Circular No. 41 / 2023

Field Safety Notice of BD Alaris™ System PC Unit 8015; Alaris™ PC Unit 8015 from Becton Dickinson & Co. (BD).

PRODUCT NOTIFICATION – MMS-23-4612

BD Alaris™ System PC Unit 8015; Alaris™ PC Unit 8015

Figure 1: The back of the BD Alaris™ System PC Unit with the 802.11 b/g or 802.11 a/b/g wireless network card; the wireless network card protrudes out from the Alaris PC Unit.

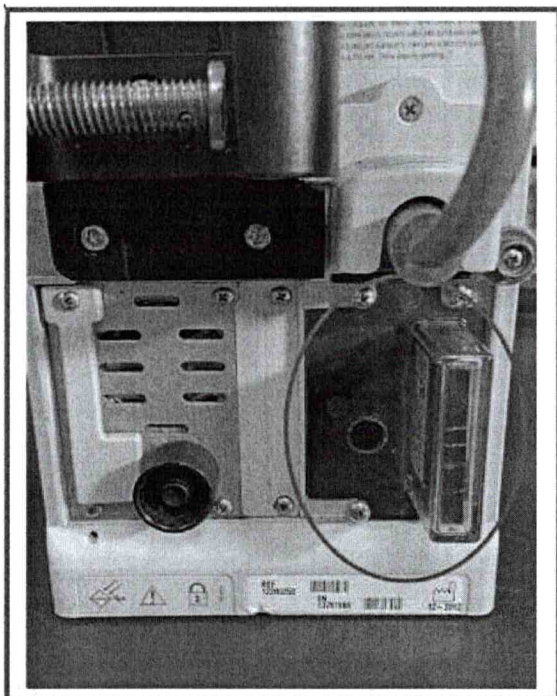
Based on customer feedback, BD has identified that when a BD Alaris™ System PC Unit with software versions 12.1.0, 12.1.1, 12.1.2 or 12.1.3 is used with a **802.11 b/g** or **802.11 a/b/g** wireless network card (refer to Figure 1), failure to establish a network connection can occur for IP addresses that are in a specific range from, **x.x.x.224** to **x.x.x.255**.

A BD Alaris™ System PC Unit with this wireless network card is impacted by the issue.

- i. Exclude IP address ranges ending in **x.x.x.224** to **x.x.x.255** from all the DHCP scopes where the BD Alaris™ System PC Units are being utilised.
- ii. Assign the BD Alaris™ System PC Units IP addresses utilising DHCP reservations to prevent the BD Alaris™ System PC Unit from obtaining an IP address in the aforementioned range.
- iii. Assign the BD Alaris™ System PC Units a static IP address outside of the aforementioned range.

Figure 2: The back of the BD Alaris™ System PC Unit with the 802.11 a/b/g/n wireless network card; the wireless card is near flush with the Alaris PC Unit.

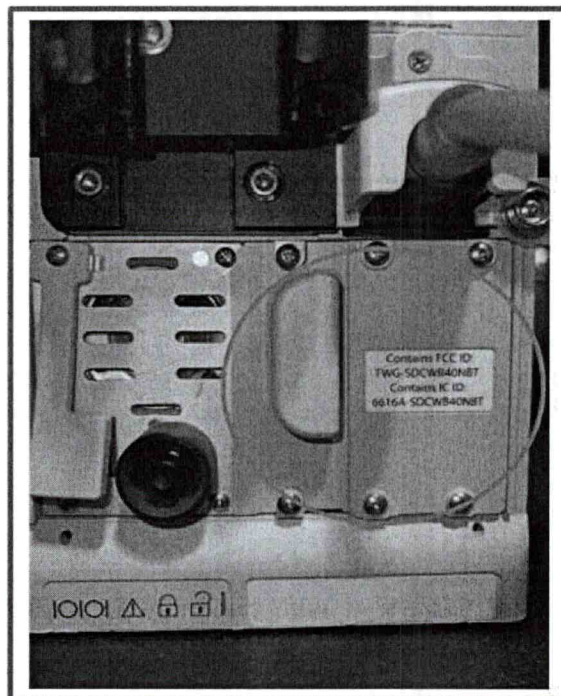
BD Alaris™ System PC Unit with the **802.11 a/b/g/n** wireless network card (refer to Figure 2) is not impacted by this issue.

A BD Alaris™ System PC Unit with this wireless network card is not impacted by the issue
